Addendum 01 for RFB9527.00-01

Project Name: HHS CHMHI Four Corner Elevator Replacement
DAS RFB#: 9527.00-01
DAS Project #: 9527.00
Date: 9/21/2026

- Cover Page (1 page)
- Questions (1 Page)
- Spec Sections and Drawings: (24 pages)
 - 0044116R – Bid form
 - Added Bid package 05 – Combine Bid Packages 01, 03 and 04
 - 142110 – Elevator Modernization
 - Paragraph 1.01G. Summery, add item 32: “Provide card access to basement level only, connect to existing card access systems.”
 - Paragraph 1.01G Summery, item 6, Corrected to include plastic laminate interior cab panels.
 - Paragraph 2.04 A 2: Controller: Omit Remote Elevator Monitoring
 - Paragraph 2.04 E 5: Platform, Existing: RETAIN
 - Paragraph 2.04F 6b: Omit Hall lanterns
 - Drawings
 - Sheet A2.08 – Floor Plans and Sections
 - Added keynote for card access at basement level
- Meeting Minutes (16 pages)

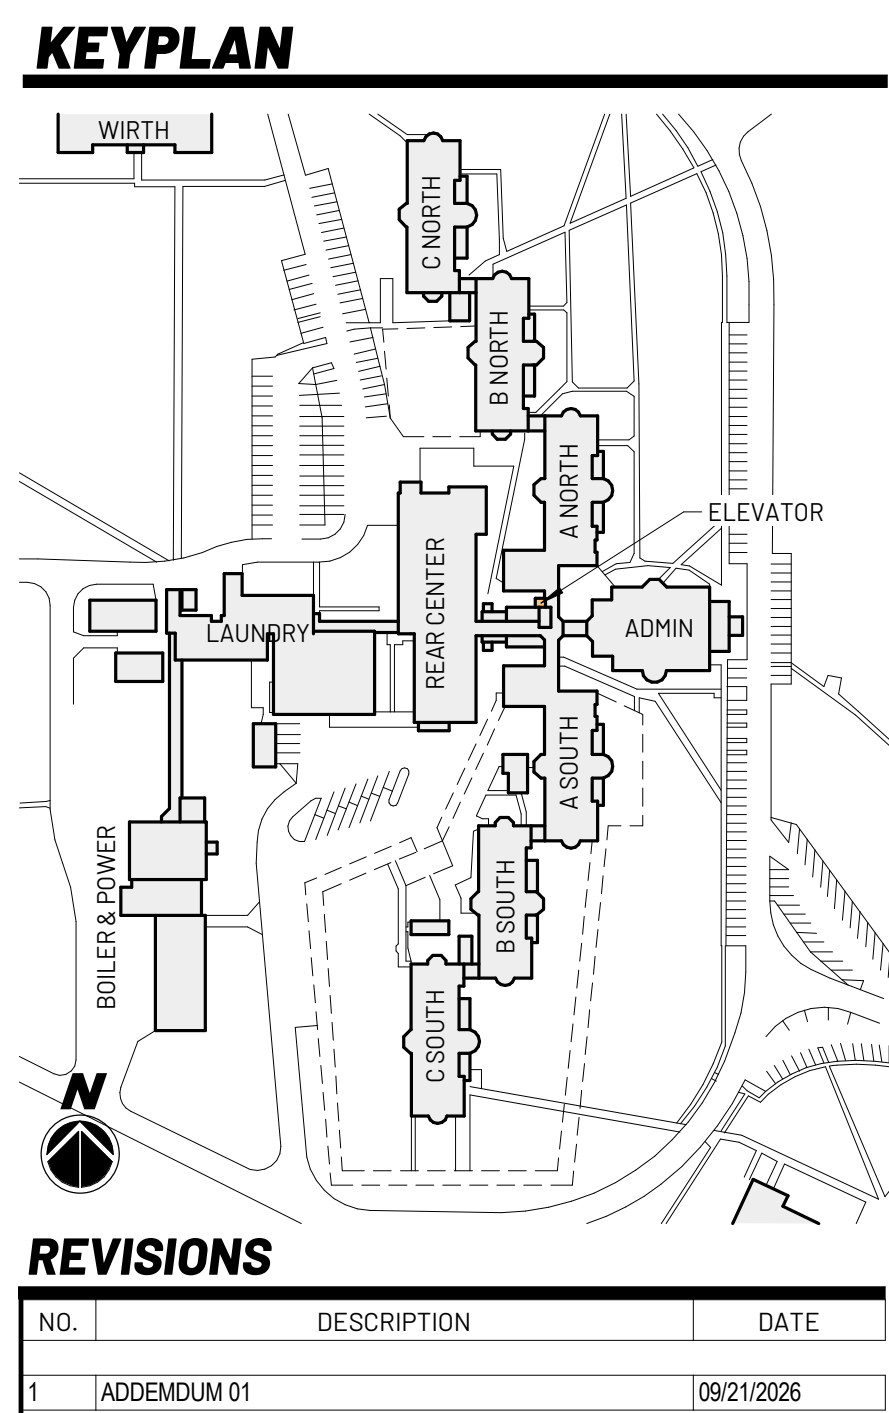
- 14 NEW CAR DIRECTION INDICATORS
 - 15 REMOVE EXISTING VENT AND INFILL WITH LIKE MATERIALS
 - 16 PATCH AND REPAIR HOISTWAY FRAMES
 - 17 PROVIDE NEW CARD READER ACCESS AT BASEMENT LANDING ONLY. SURFACE MOUNT IN CORRIDOR AND IN CAB
